AGENDA
Design Review Committee
May 8, 2024 – REGULAR MEETING
5:30 PM

Item Number: P22-254

Address: 910 Smith Lane and 915 Simon Lane

Recommendations: Final Review

2 | PREVIOUSLY APPROVED NORTH ELEVATION (FROM 11/03/2022 DRC ADDENDUMS SUBMISSION)

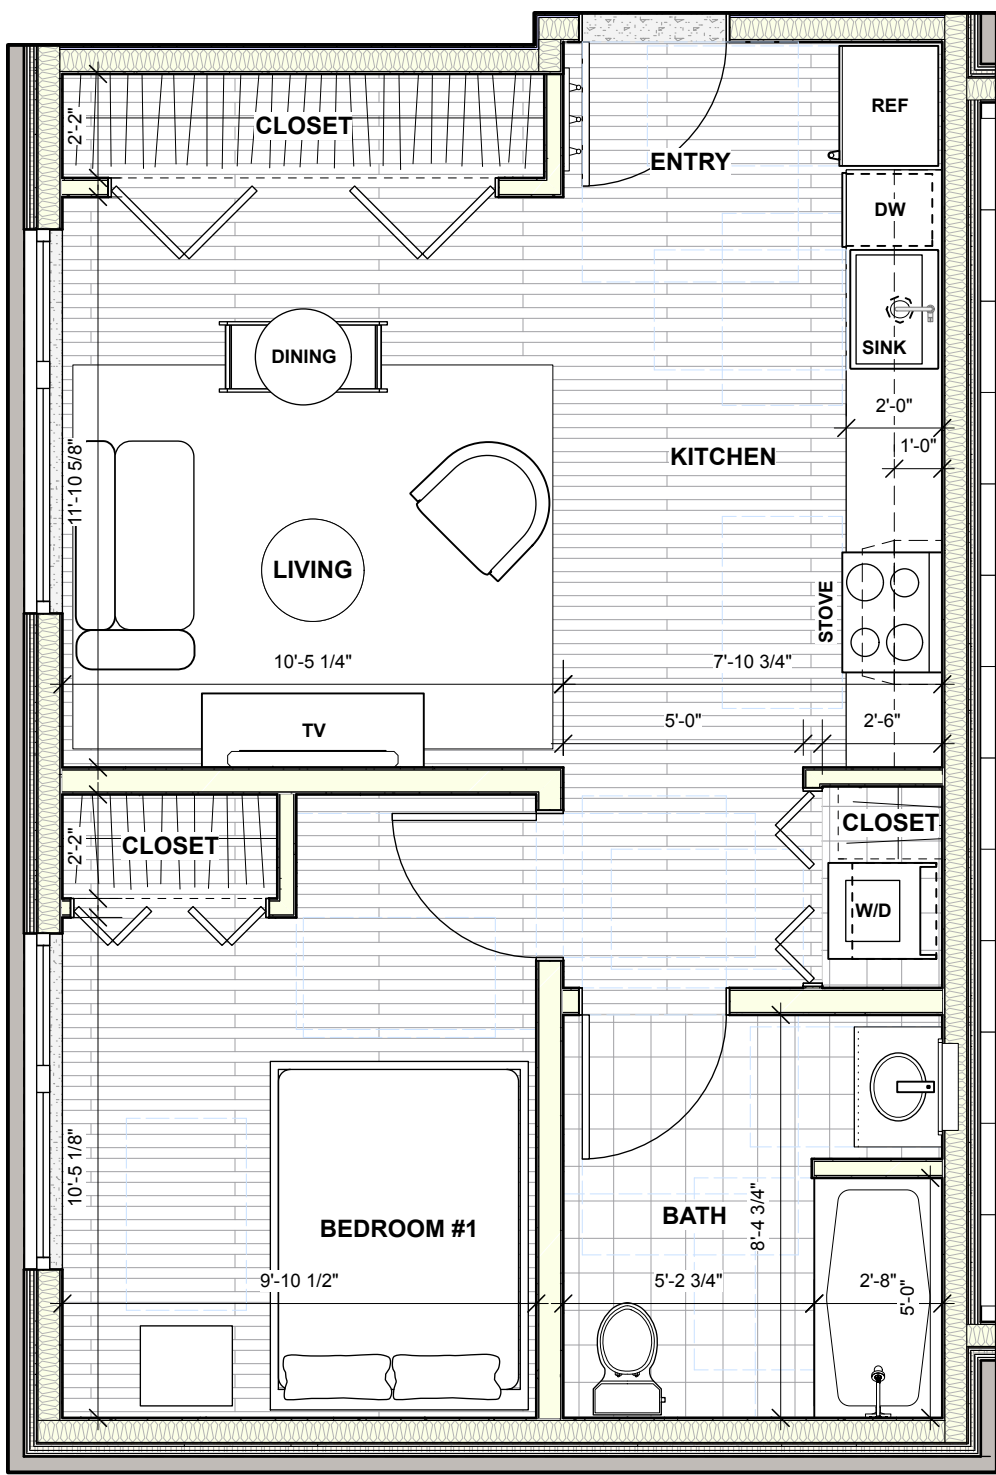
- **Upper Two Floors**
 - Corridor and unit floor plan changes.
 - Changes to fenestration due to floor plan reconfiguration

ENLARGED EAST ELEVATION

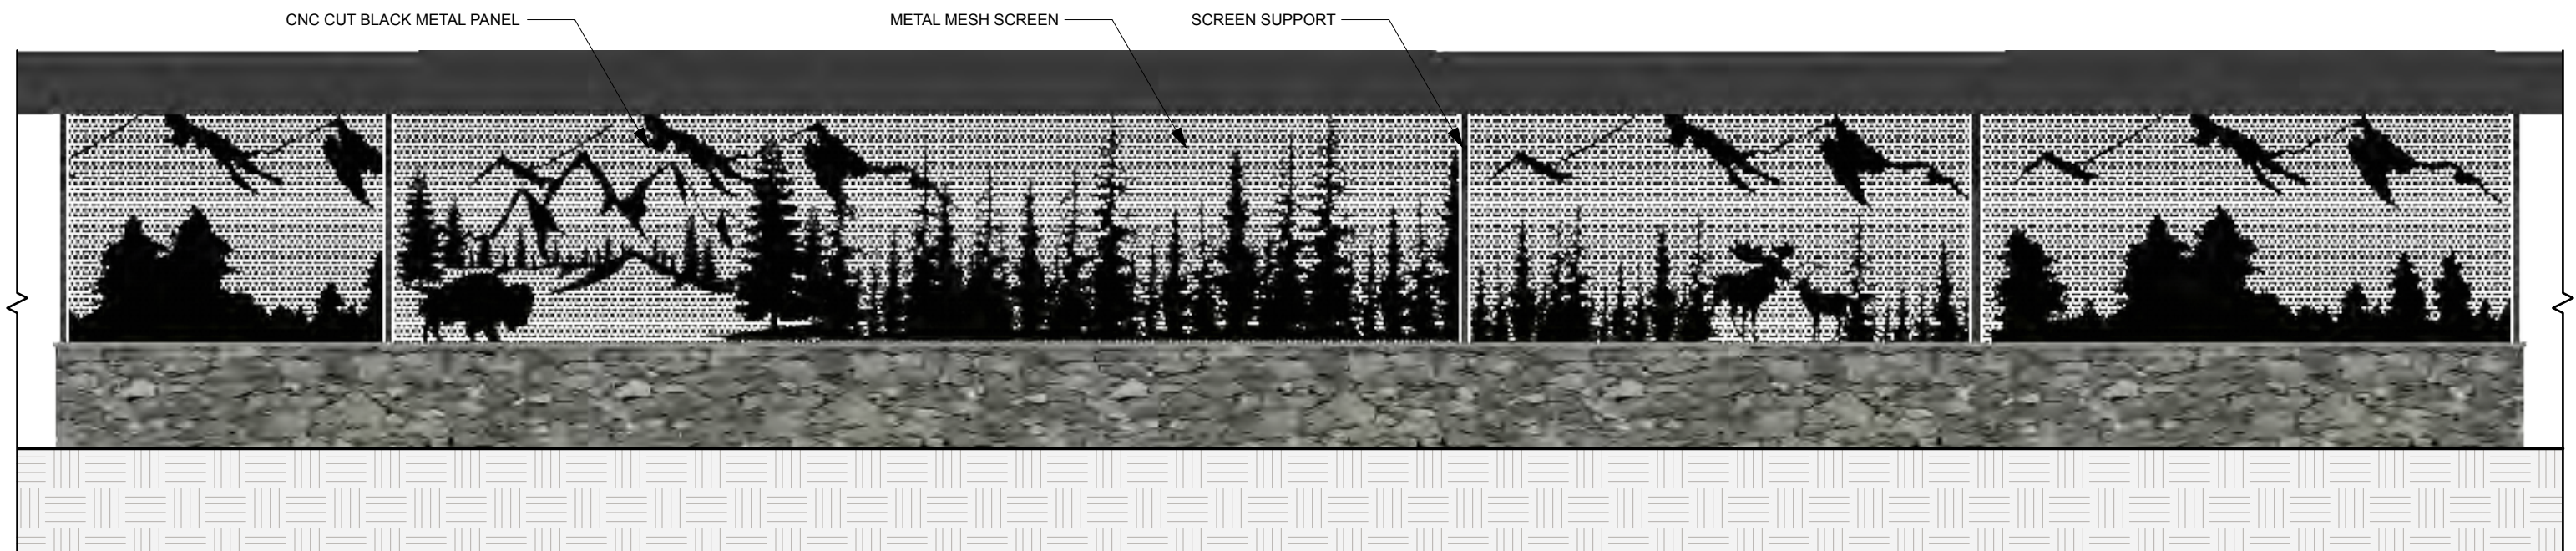
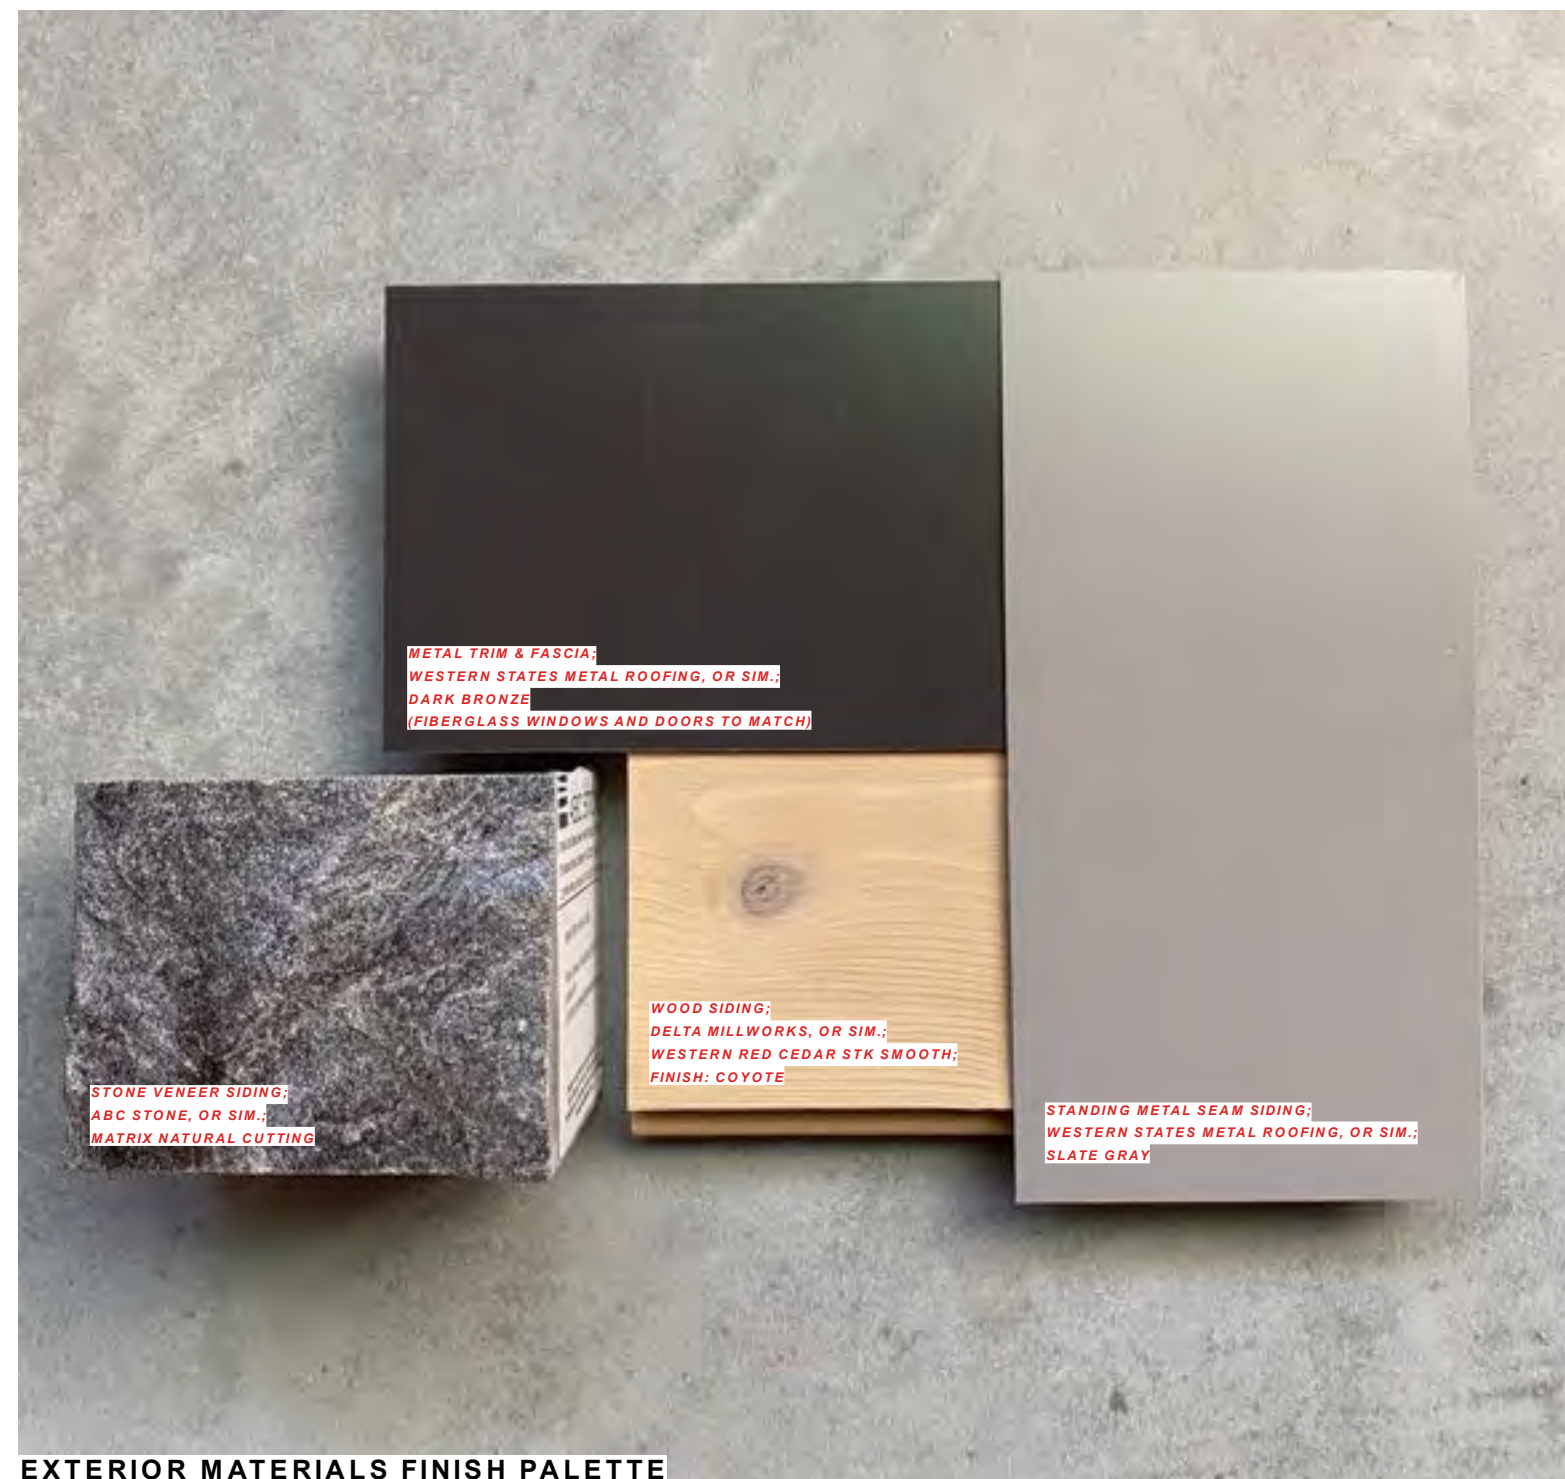
Staff do not address overall massing or material selection in this staff report as there are no significant changes to those aspects of the design guidelines. One new material – cut black metal panel – is described in further detail below and provides screening detail along the Scott Lane frontage where windows to lobby were previously proposed.

Previously, the floor plan included an entrance to the lobby and stairwells at the ground level along the eastern façade with windows along most of that span. Screened parking is now provided where the lobby once was and the applicant proposes a cut black metal panel mural design in place of the window bank in order to provide screening to the parking garage.

Within the property there are varying scales and types of open space. To the north a large landscape area with public bike parking. To the south a large landscape area and to the east a mural screen wall and walkway with planting and areas with benches for seating.
